Readout System Review

Electronics Upgrade Meeting, April 10th 2014

Readout System Review

Optical fibres 2 - test at P8

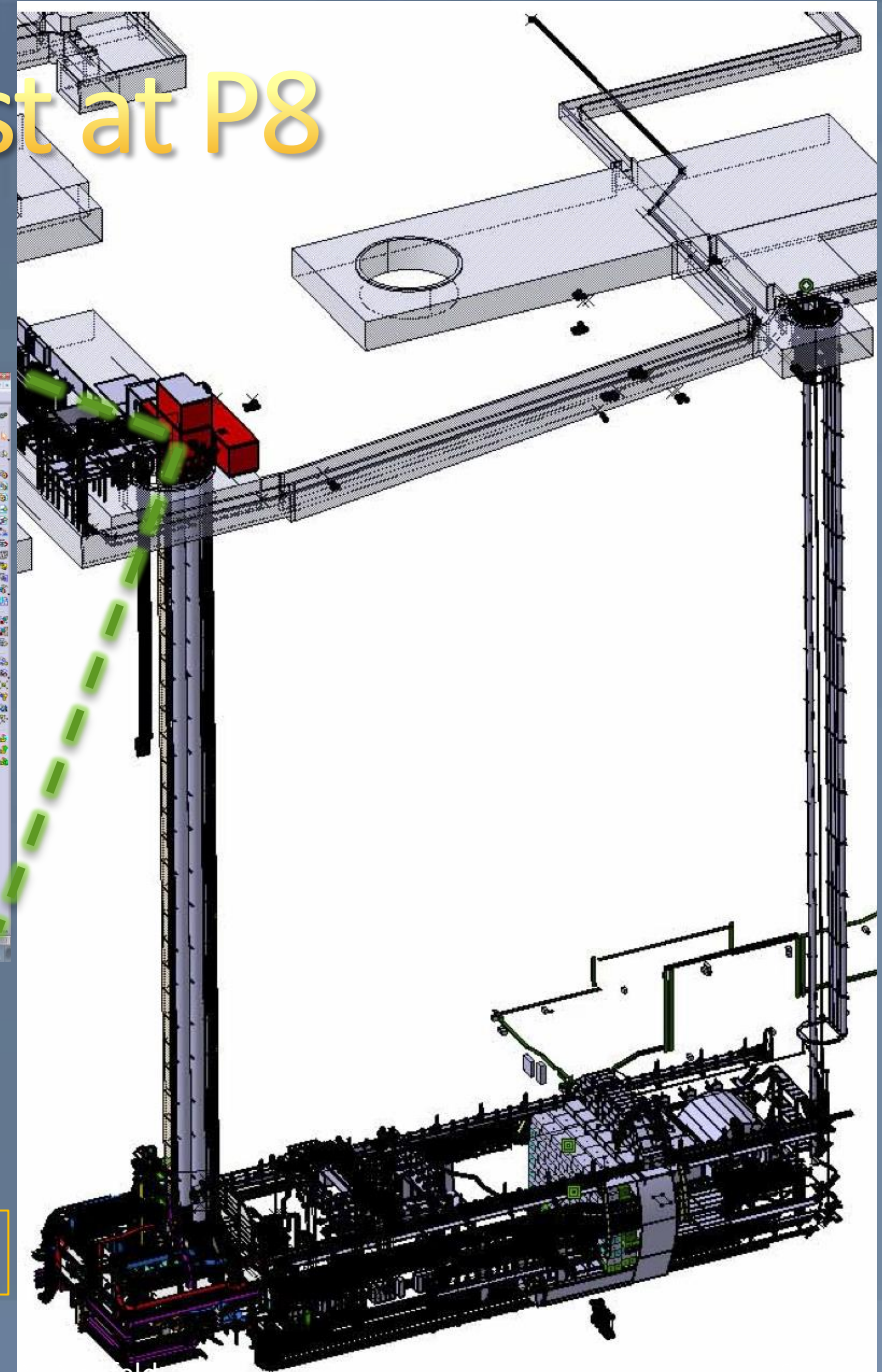
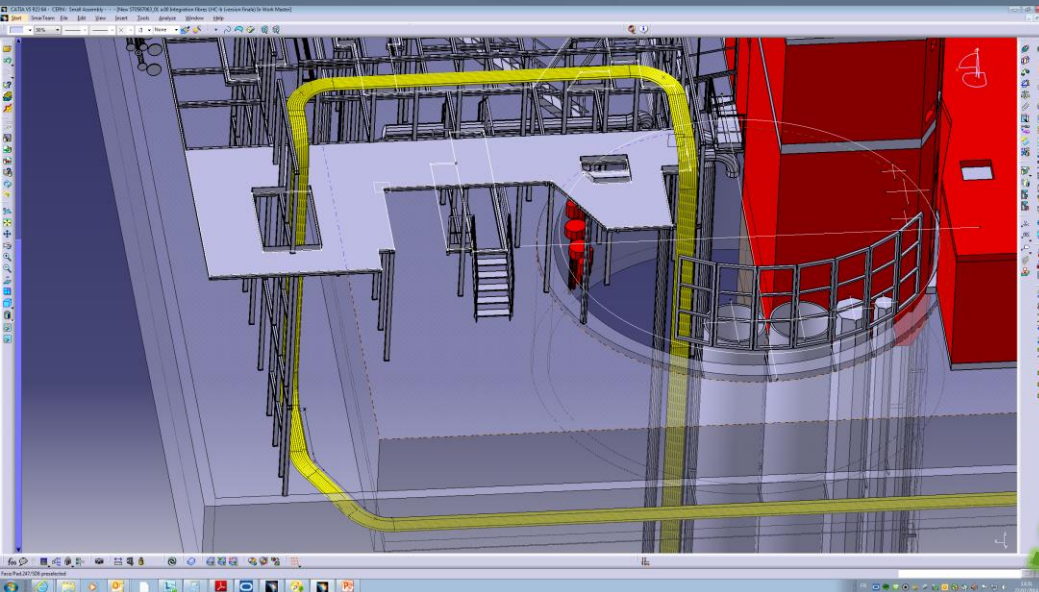
- note that no intrinsic advantage of OM4 for current application is identified. Price difference for material currently 50% (1 → 1.5 MCHF)
- **In situ tests:** “[...] recommend that the testing be repeated on a test span of both OM3 and OM4 fibre that are installed in the LHCb experimental area via the proposed fibre route. This would allow unforeseen effects to be observed.”

SD8 – try to get rid of 30 m loop

- Choose “worst” (== longest distance, most bends) point in cavern (in the bunker)
 - We will need some space!
- Planning:
 - Before June 2014 (cool-down start): install support structures in PM85 et US85
 - Before December 2014 (closure of cavern): install supports in surface gallery and UX85
 - Install prototypes of both solutions (blown fibres (from bottom to top and pre-connectorized cables (OM3 and OM4)
- Long-term tests starting from 2015 (with beam)

Evolution 2 - Architecture

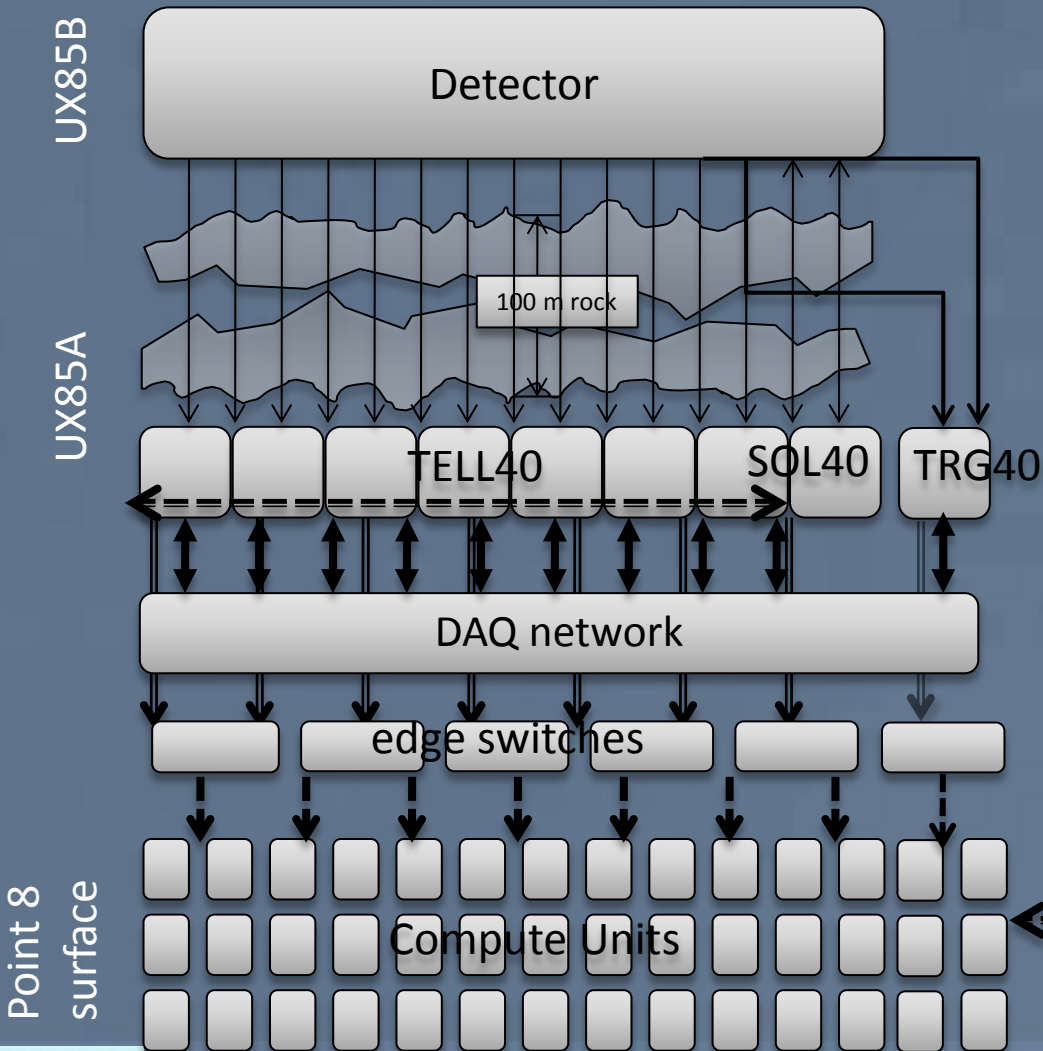
- Basic question to reviewers: “We propose a change of baseline from ATCA/AMC to PCIe. Do the reviewers support the choice of baseline (PCIe) and back-up (ATCA)?”
- Basic answer:
“Given the listed advantages the review committee endorses the choice of the PCIe based design as a baseline.”

AMC40 \rightarrow PCIe40 + PC
